**Charleston Armory HVAC Renovations
And Architectural Improvements
DEFK - 9013**

Addendum No.: 2
Issue Date: May 12, 2009
Architects Project No.: 115063
Bid Opening: 1:30 p.m. May 20, 2009

From: **Michael Baker Jr., Inc.**
5088 Washington Street, West
Charleston, West Virginia 25313

Drawing Number:
E1.2
 Sheet 1 of 1

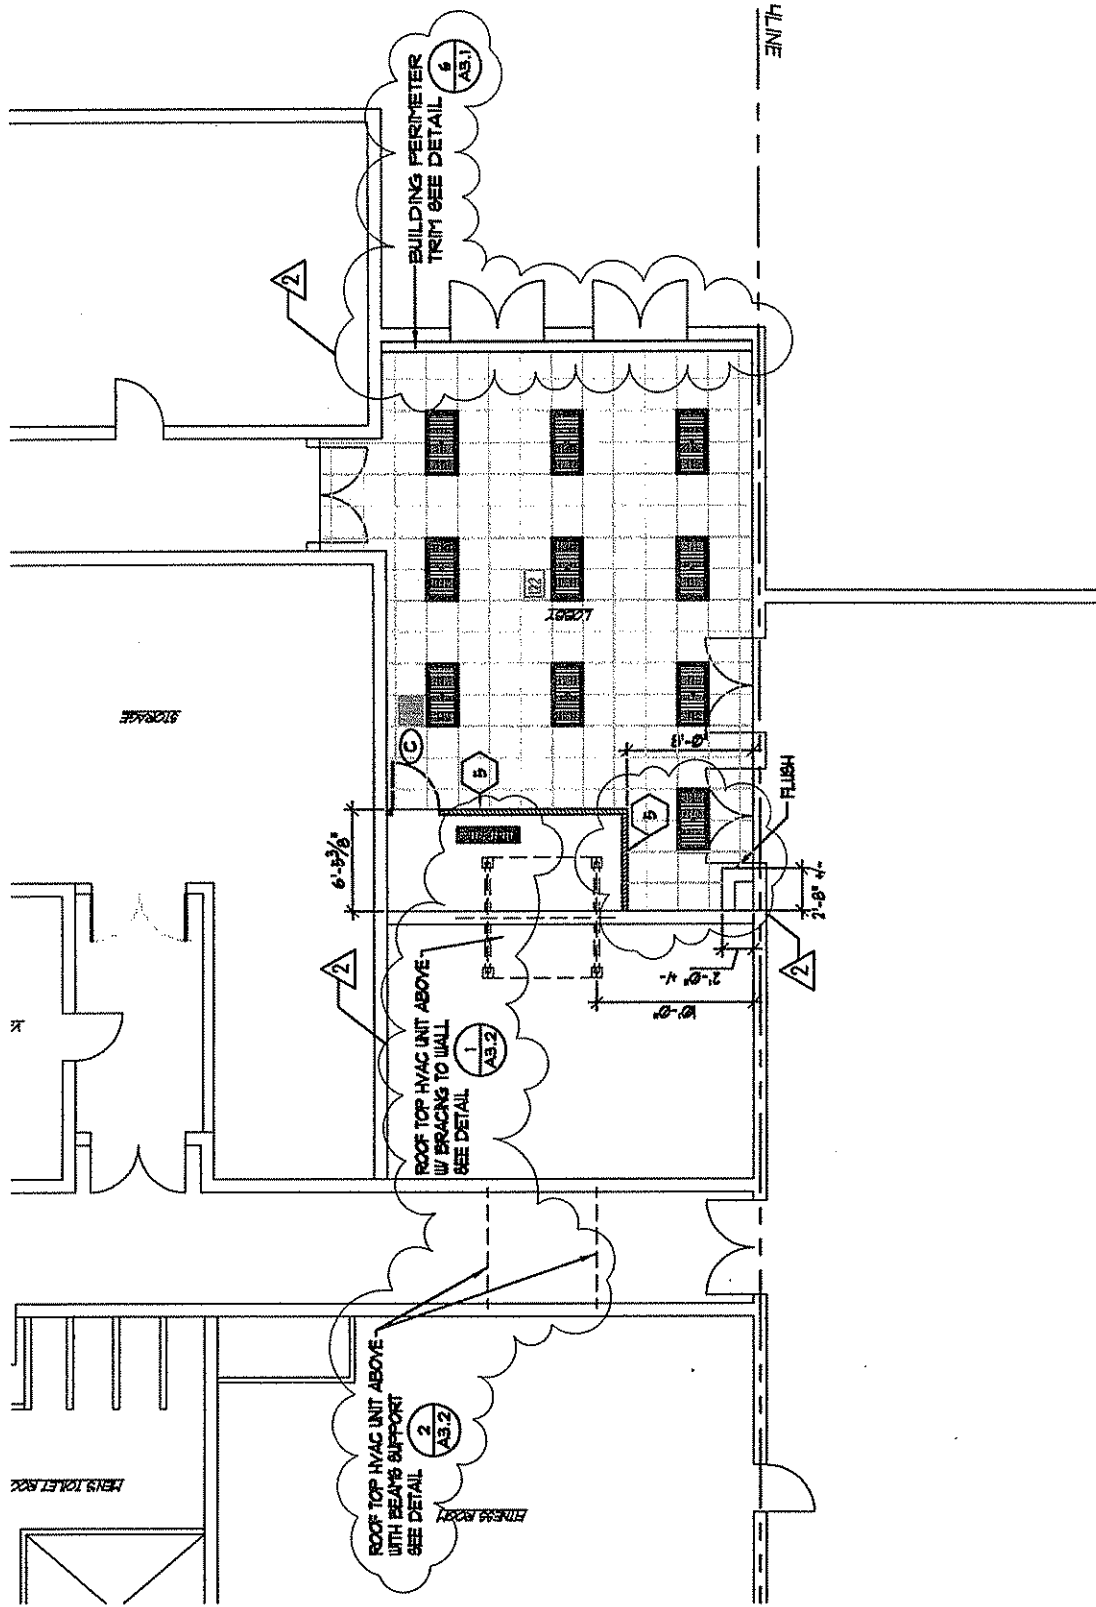
44. REVISE Drawing E1.2 as per Attachment A2.13. This drawing includes a revision of the Lighting Layout.
45. ADD the following notes to the below referenced Mechanical Drawings:

Drawing Number:
A2.1
 Sheet 1 of 1

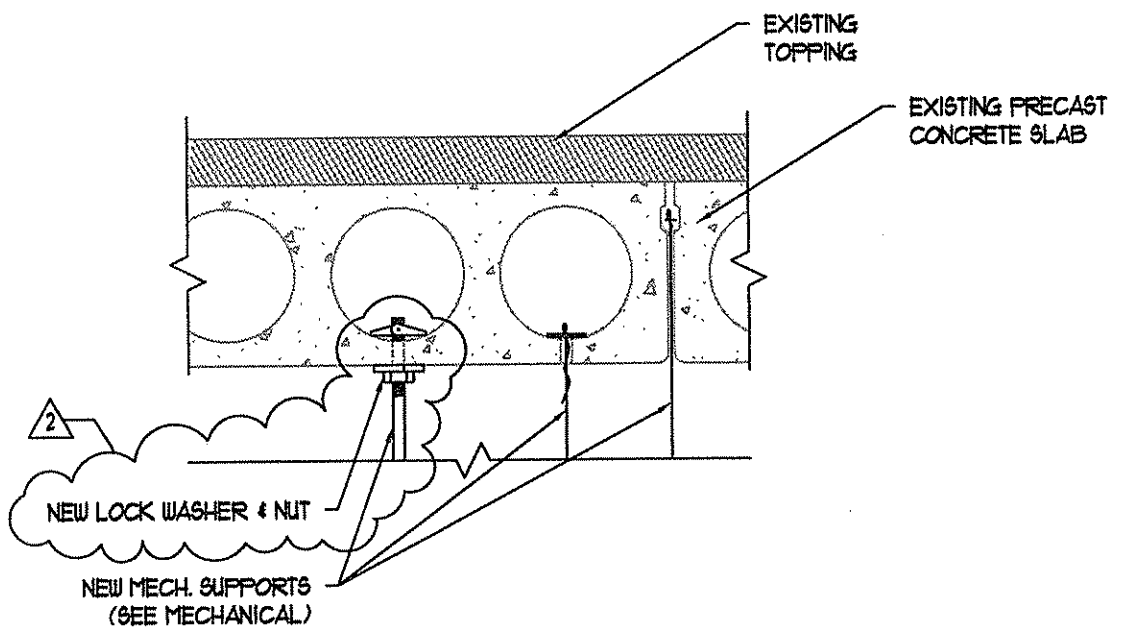
- A2.1 – Drawing A2.1– Revised Detail 3 - 1 page
- A2.2 – Drawing A3.1 – Revised Detail 11 - 1 page
- A2.3 – Drawing A3.2 – Revised Details 1 & 2 - 1 page
- A2.4 – New Elevation Drawing - 1 page
- A2.5 – New Elevation Drawing – New Detail - 1 page
- A2.6 – Drawing M1.2 – Revised Drawing - 1 page
- A2.7 – Drawing M1.2 – Revised Drawing - 1 page
- A2.8 – Drawing M1.2 – Revised Drawing - 1 page
- A2.9 – Drawing M1.2 – Revised Drawing - 1 page
- A2.10 – Drawing M0.1 – Revised Schedules - 1 page
- A2.11 – Drawing M1.1 – Mailroom Revision - 1 page
- A2.12 – Drawing M1.2 – Lobby Duct Revision - 1 page
- A2.13 – Drawing E1.2 – Revised Lighting Layout - 1 page
- A2.14 – Drawing M1.2 – Revised Drawing - 1 page

II **MECHANICAL SUPPORT DETAIL (TYPICAL)**
 A3.1 SCALE: NOT TO SCALE

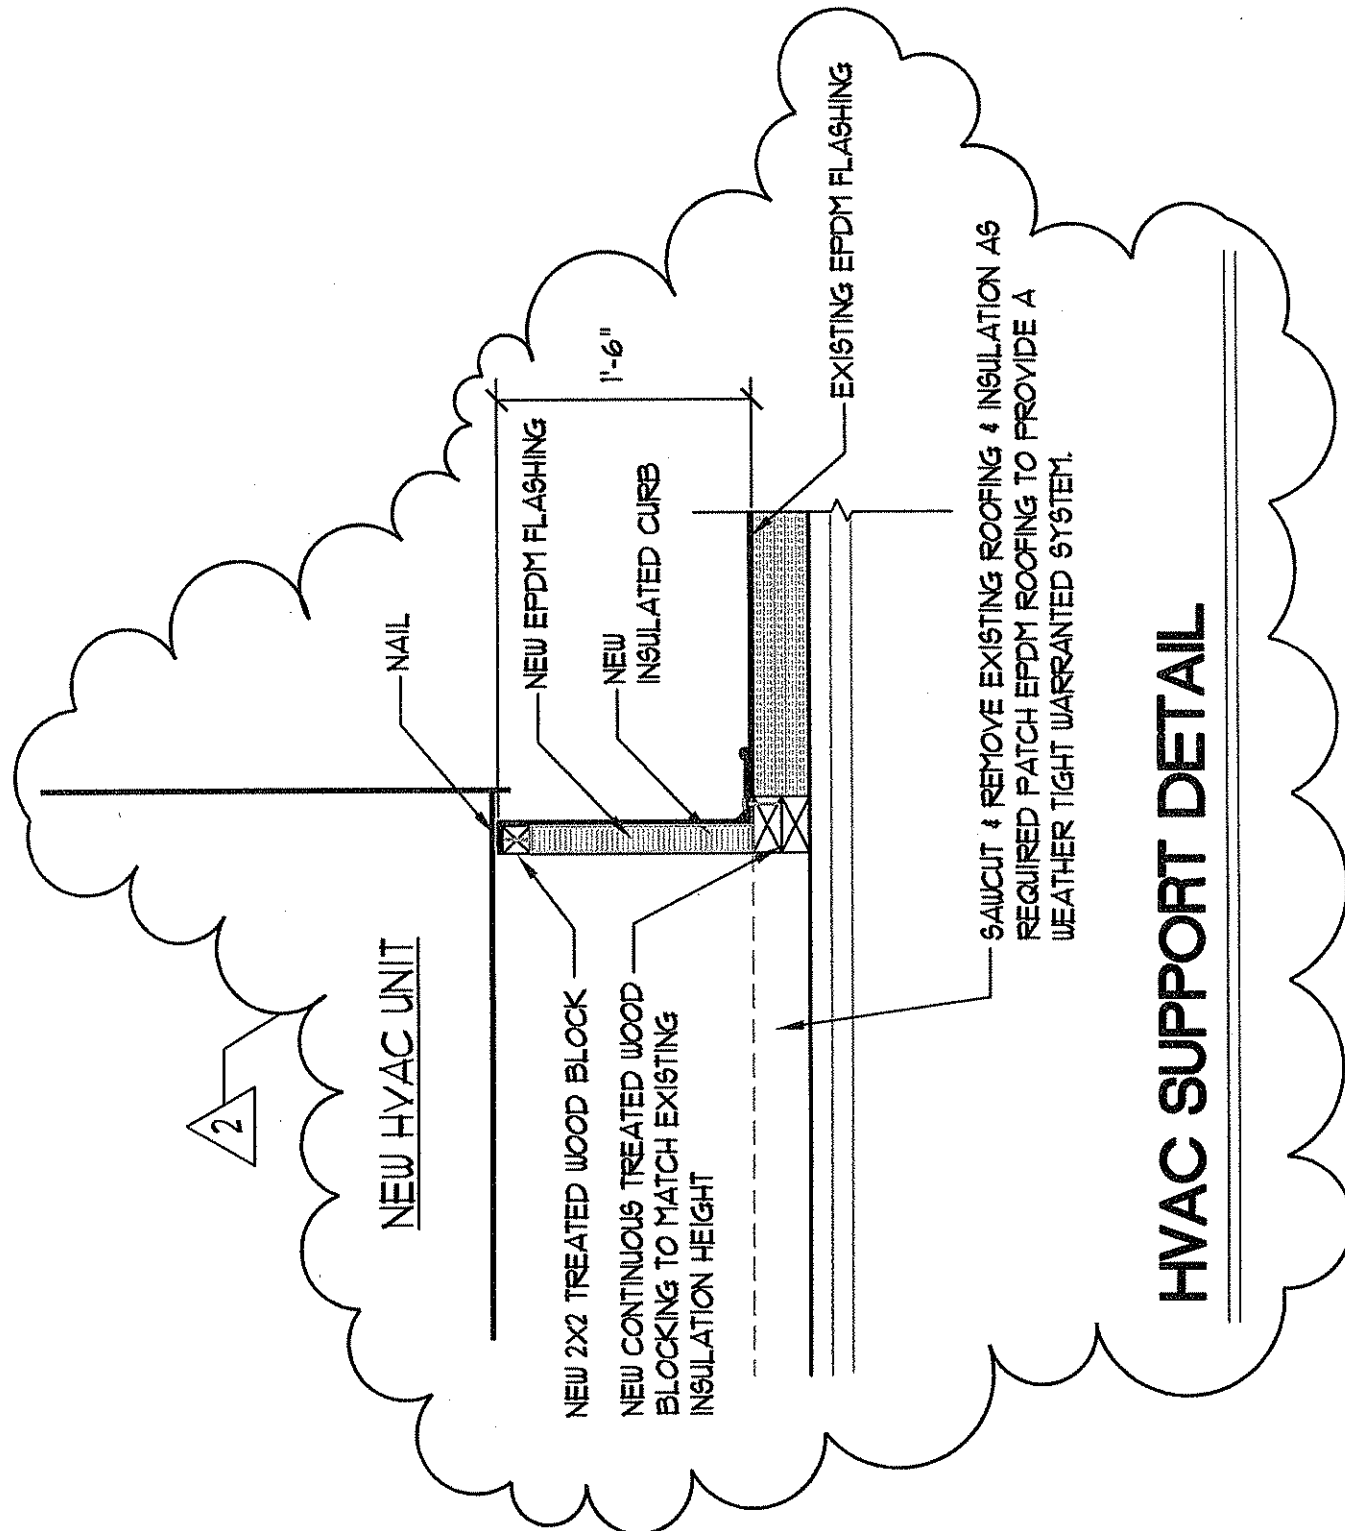
25. REVISE Detail 11 on Drawing A3.1 as per attachment “A2.2”. This attachment was inadvertently omitted from addendum 1 (attachment “A1.8”).

HVAC SUPPORT DETAIL

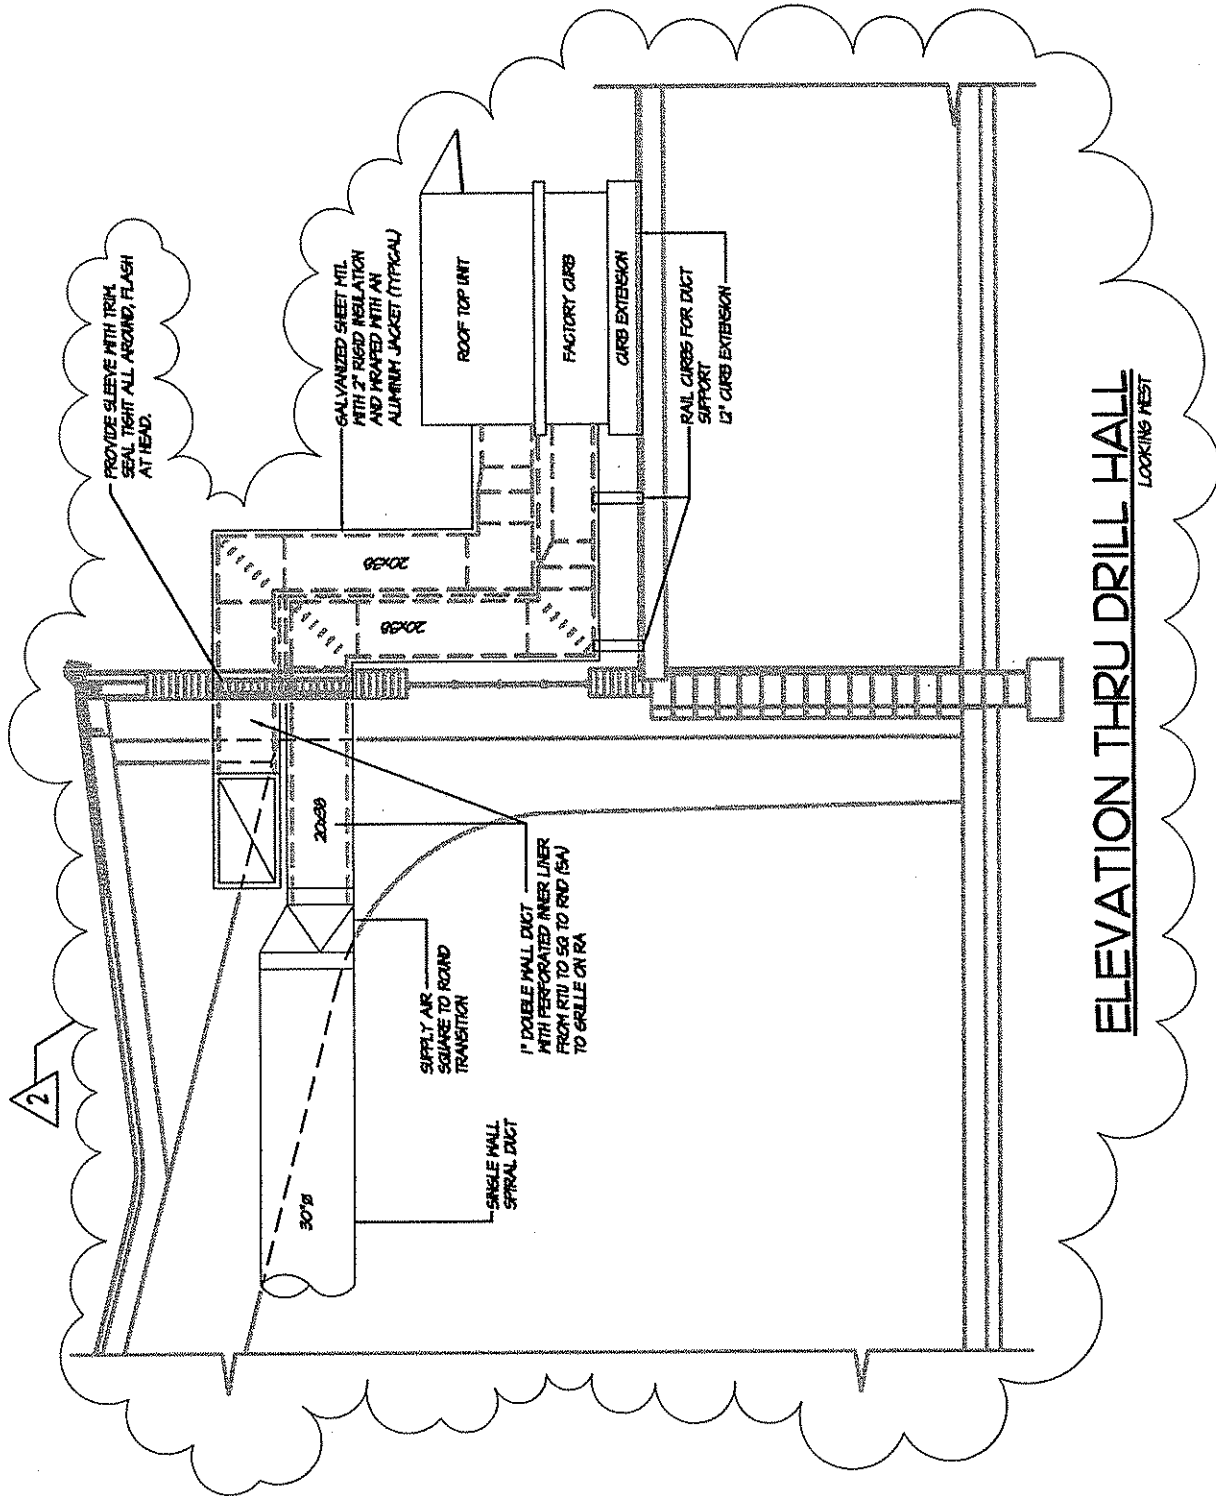
26. REVISE Details title tags on drawing A3.2 to read 1/A3.2 “Soffit and HVAC Support Wall A Detail” and 2/A3.2 Soffit and HVAC Support Wall B Detail”. REVISE curb flashing on both details as per attachment “A2.3”.

ELEVATION THRU DRILL HALL
LOOKING WEST

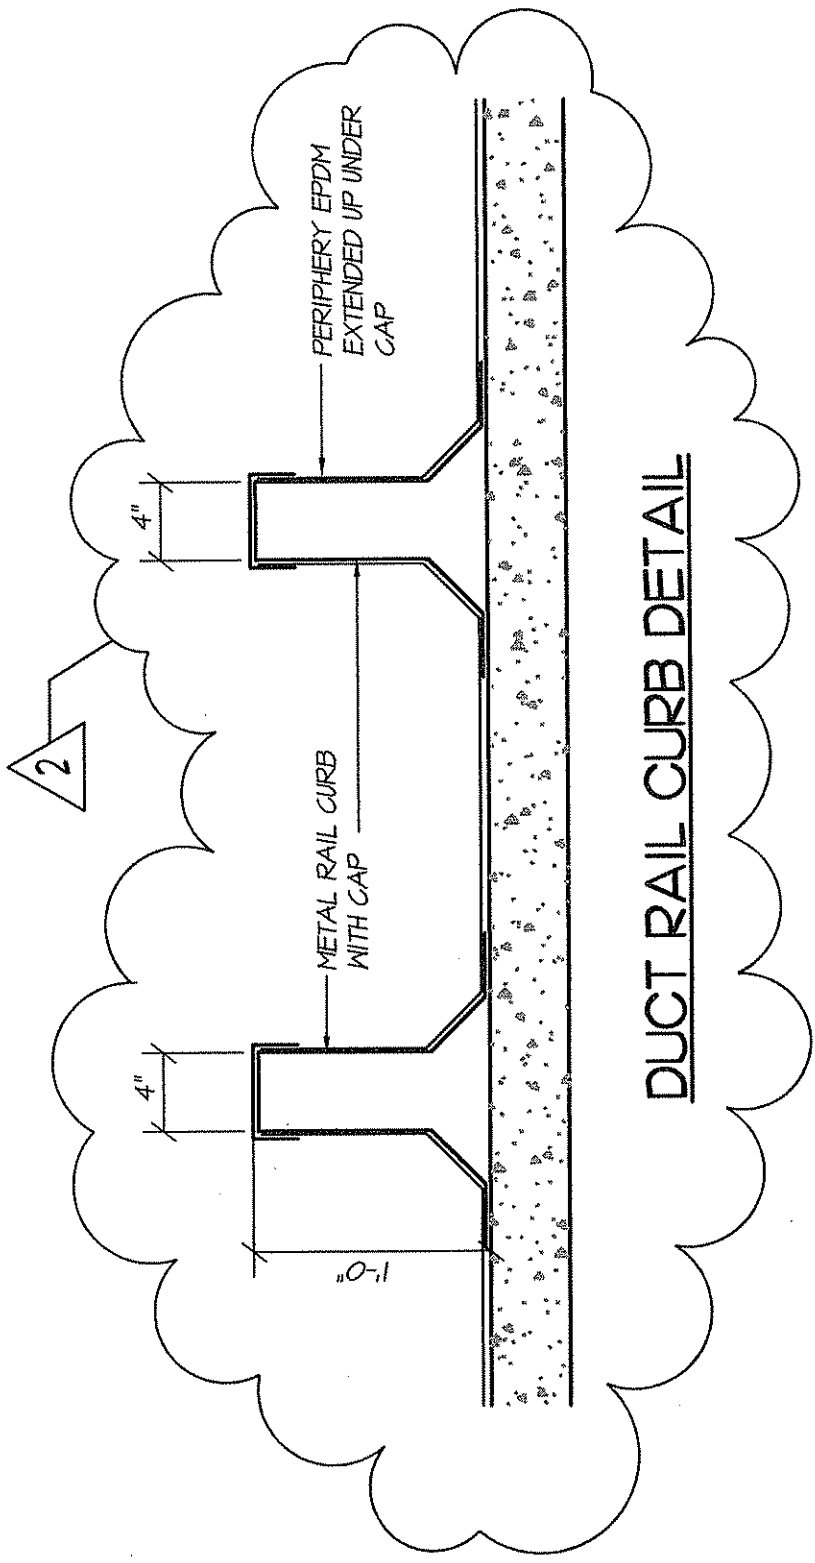
33. CLARIFICATION Drawing ME1.4:
Provide pre-insulated steel pipe and fittings from mechanical room wall to fluid cooler.
 34. ADD New Elevation View of the Drill Hall looking west toward the RTU Wall penetration per attachment "A2.4".

| Drawing Title: DUCT RAIL CURB DETAIL | Date: 5/11/09 |

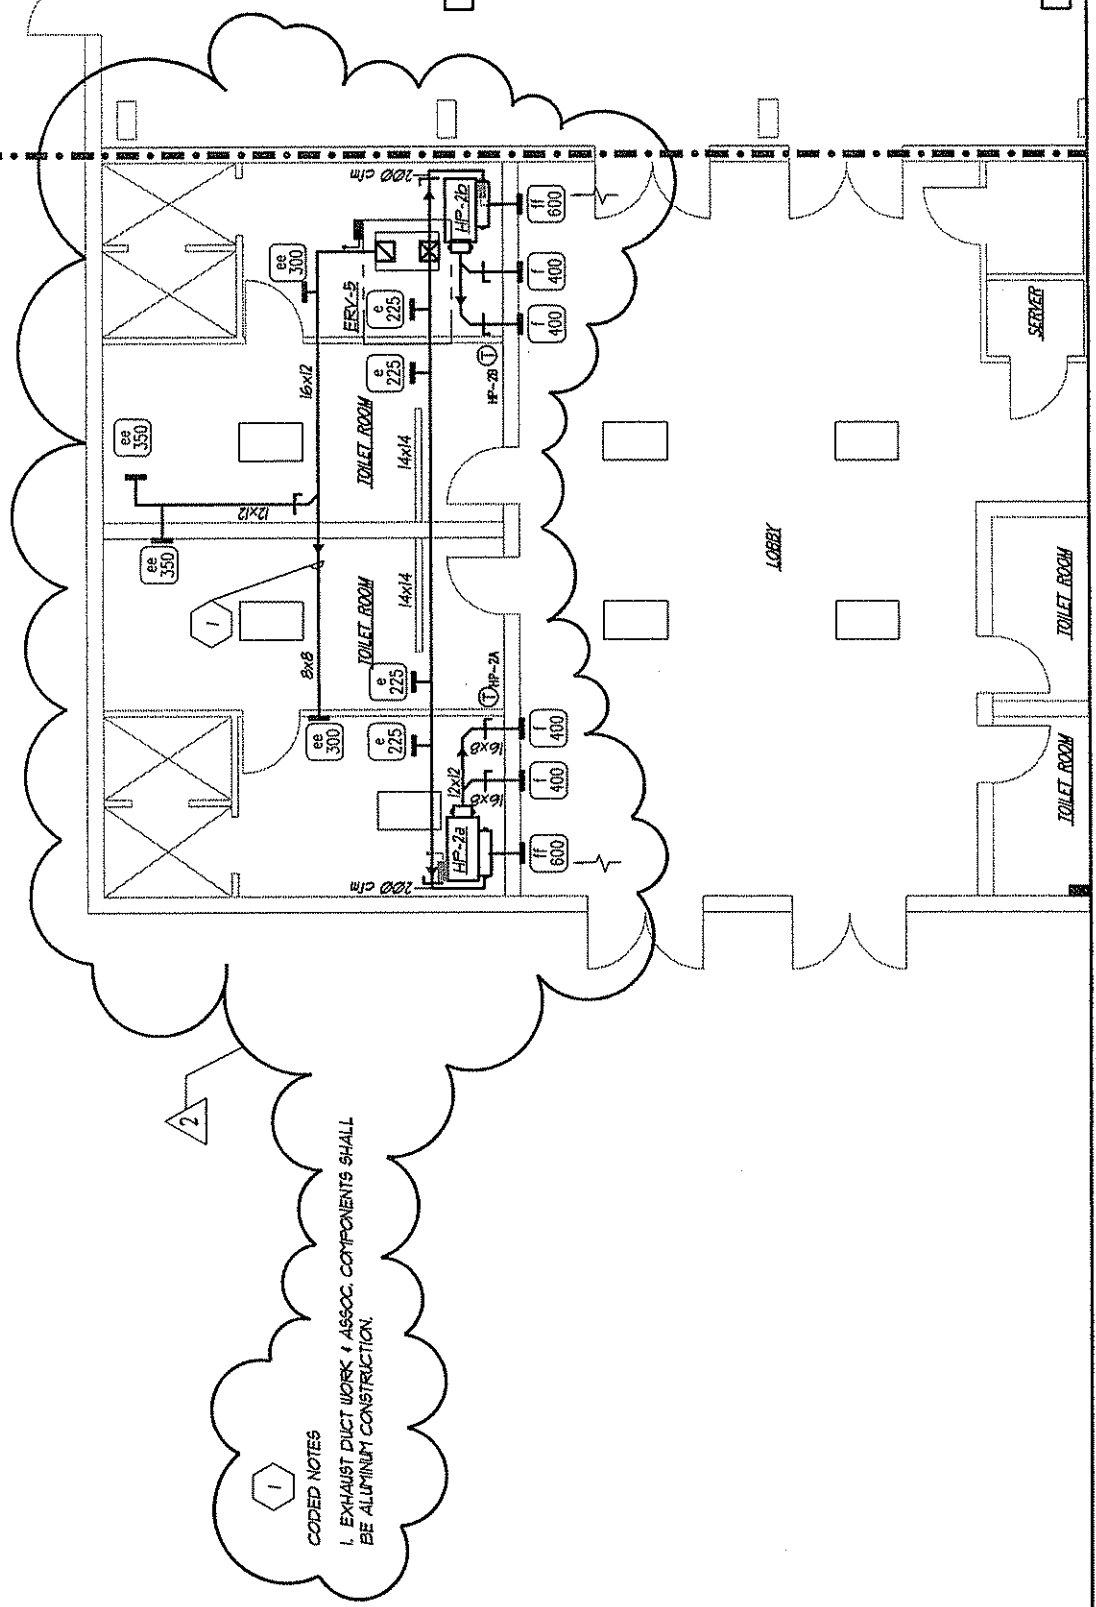
35. ADD New Detail supplementing the Elevation listed in Item 34 above. This drawing is titled "DETAIL DUCT RAIL" and is attachment "A2.5".
 36. ADD the following general note to drawings M1.1 – M1.4. Add ½" ductliner to all exposed rectangular supply and outside air ductwork from Heat Pumps and ERV's. Duct sizes shown are clear inside dimensions. Increase duct sizes for liner.
